STAFF REPORT 01-22-2020 REGULAR MEETING

APPLICATION NUMBER: 20-6608

ADDRESS: 31 ARDEN PARK BOULEVARD (HENRY STEINBRECHER HOUSE)

SCOPE: ERECTION OF FENCE (WORK COMPLETED IN VIOLATION)

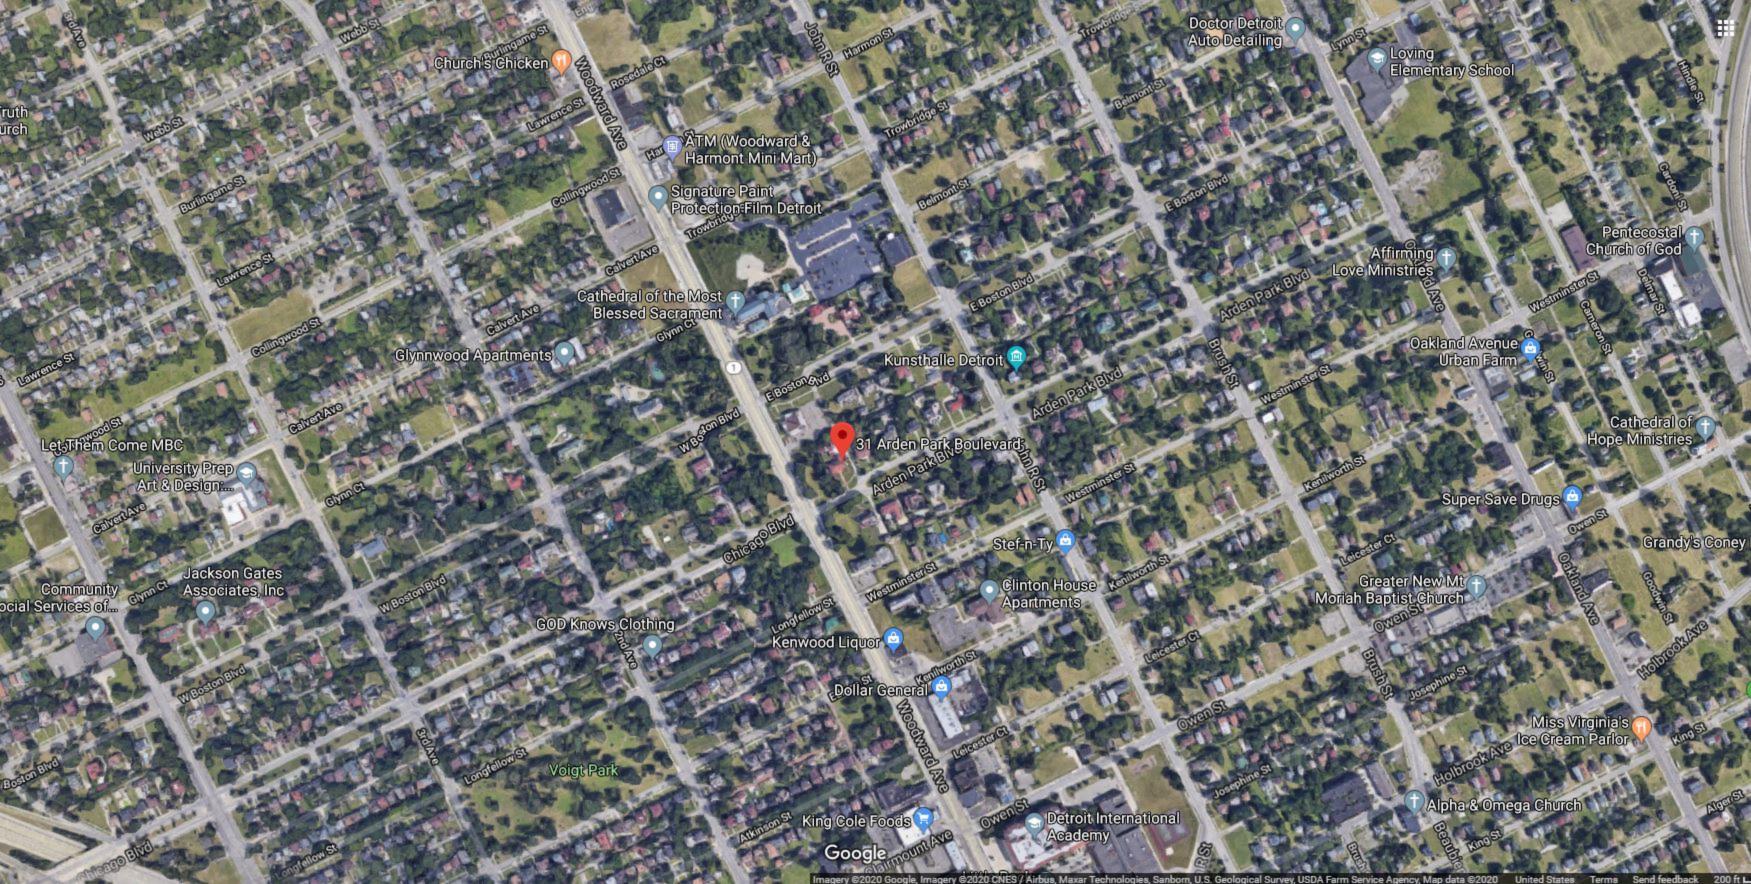
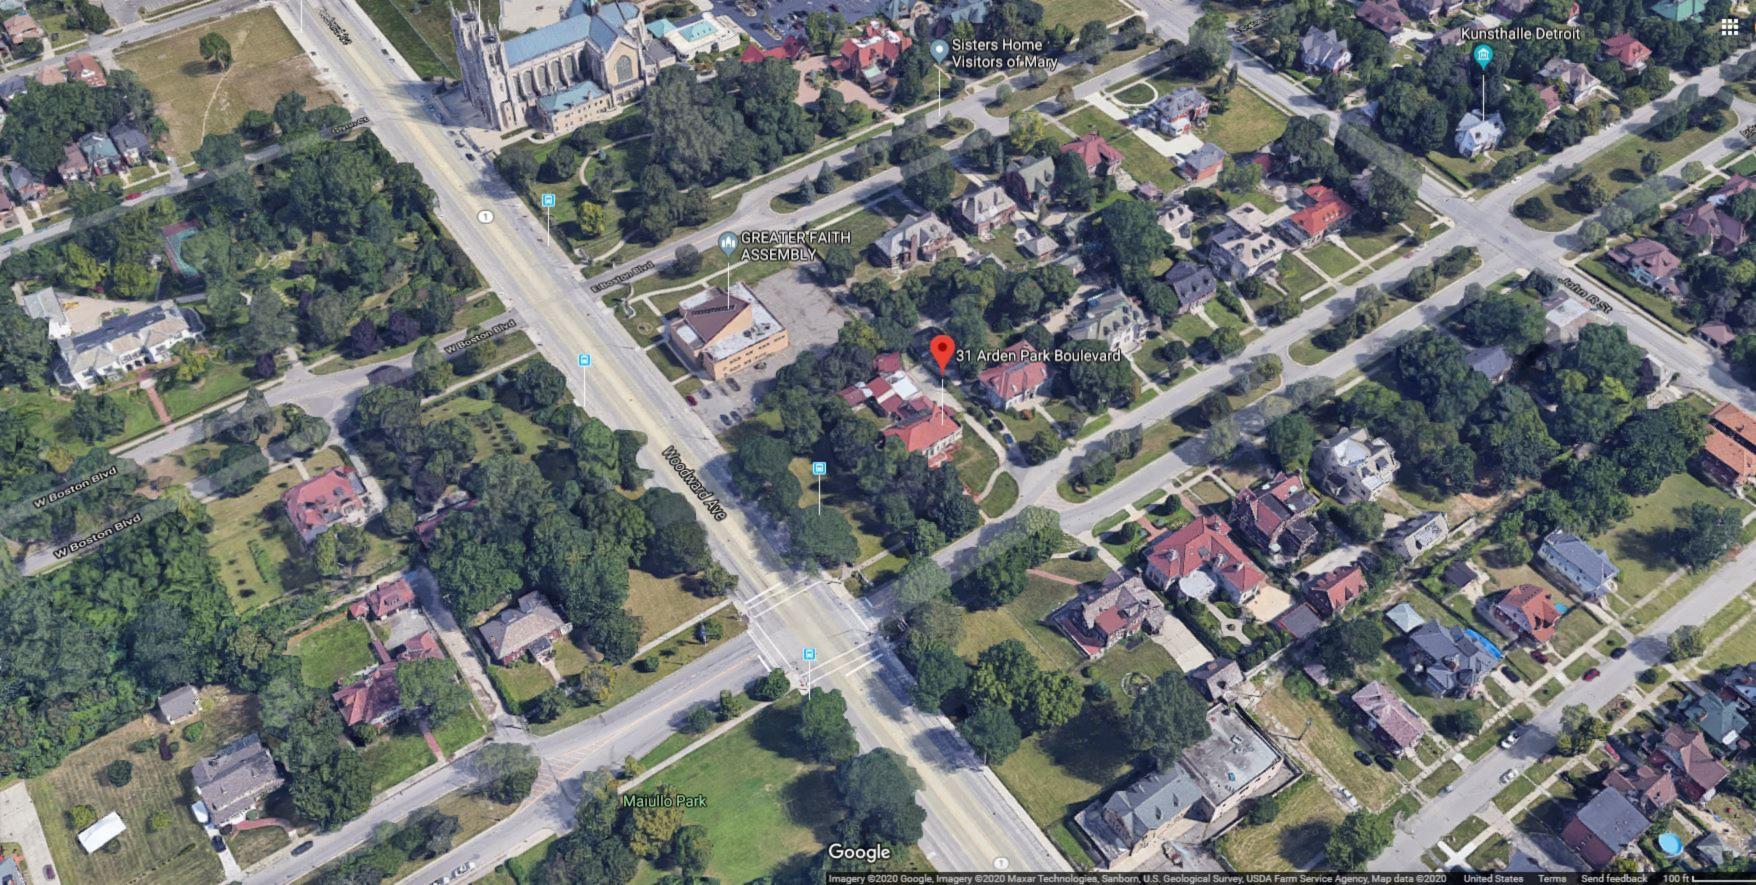
- The 8' height of the new fence does not meet the Commission's Fence & Hedge Guidelines as an allowable height at side lot lines. Additionally, not all of the fencing found on the property was replaced, only a portion of it. The remaining fence along the east lot line is black wrought iron, a short portion of chain link fence extends perpendicular to the new fence at the south elevation -- past the front face of the house, and a small section of 8' tall wood fence exists adjacent to the driveway west of the house. See submitted diagram for locations and fence types. Note that the portion of the chain link fence that exists perpendicular to the new wood fence at the front yard (past the front face of the house) is not represented in the diagram. There are currently 3 types of fencing material on the lot which does not meet the Commission's Fence & Hedge Guidelines which state, "A single lot shall contain no more than two types of fencing material."

- The fence is currently unpainted wood. The application does not include any information regarding proposed finish for the fence.
- It is staff's opinion that the lattice portion of the new fence detracts from the historic character of the property and is therefore not considered appropriate.

However, staff recommends that the Commission issue this Certificate of Appropriateness with the following conditions:

- The lattice portion located at the top of the fence be removed.
- The fence be stained or painted to complement the house.
